E3610A-06A-S

S E R V I C E N O T E

E3610A Manual DC Power Supply

POSSIBLE SHOCK HAZARD

LOOSE AC MODULE

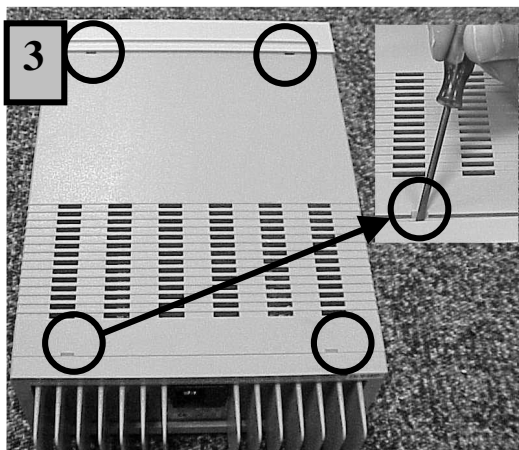
If the AC line cord is forcefully pulled in a side-to-side direction the AC Module can be pulled out of the rear heatsink, exposing the conductors that carry AC line voltage.

1. Make sure linecord is removed from outlet.
2. With linecord securely inserted in AC Module as shown, pull forcibly (2 times) in direction of arrow.

1. If the AC Module pulls out from Unit as shown it will need to be replaced.
2. If the AC Module remains in place it does not need to be changed. Put a mark on the AC input label in the lower left hand corner with indelible ink to indicate that the AC module has been checked. This label can be found below the AC module.

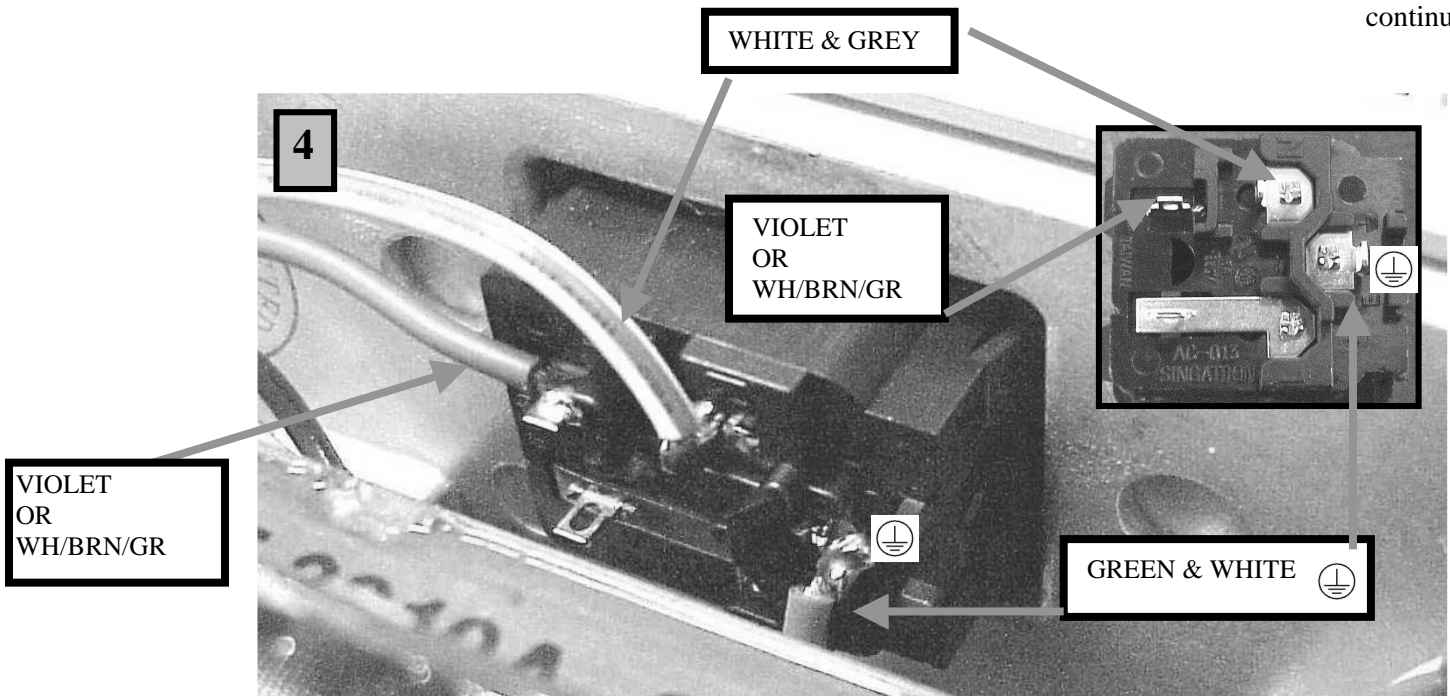
REMOVE COVER by prying Rear Bezel and Front Panel away from Cover in four places as shown. Then lift Cover off unit.

REPLACE MODULE with P/N 5185-1346. Before soldering perform “TEST FOR LOOSE AC MODULE” as shown in picture above. This will confirm that the new Module is secure. Solder wires and **REPLACE FUSE**.

100/120 VAC input use Fuse P/N 2110-0702 (2 amp, 250 volt)

230 VAC input use Fuse P/N 2110-0599 (1 amp, 250 volt)

CAUTION: WIRING MUST BE CORRECT OR HEATSINK COULD BE AT LINE POTENTIAL.

CAUTION: MAKE SURE SAFETY GROUND \oplus IS ATTACHED TO HEATSINK
